December 2nd Public Meeting Comments and Responses

BWROG/NRC Meeting
Albuquerque, NM
February 23-24, 2016

Analysis Comments

Figure 5-49
STRAINER CONDITIONAL FAILURE PROBABILITY DIVIDED INTO FAILURES
CAUSED BY EXCEEDANCE OF THE GE HEAD LOSS CORRELATION RANGE OF
APPLICABILITY AND FAILURES CAUSED BY OTHER PHENOMENA FOR THE LBLOCA
ABOVE TAF SCENARIO

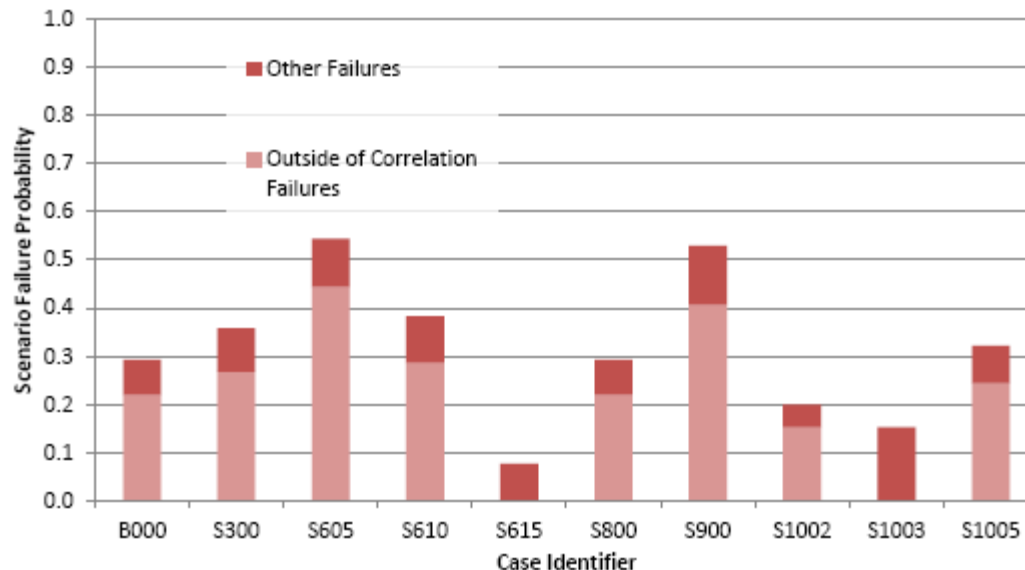
Comment: Determine how assigning scenarios outside of the bounds of the GE correlation to failure affects the conditional strainer failure probability results

Response: Results in the ECCS SS R-IS Phase II report provide failure attribution w.r.t. the GE correlation for applicable T-H cases. This comment is not applicable to Phase III since the GE correlation is not used for strainer head loss calculation.
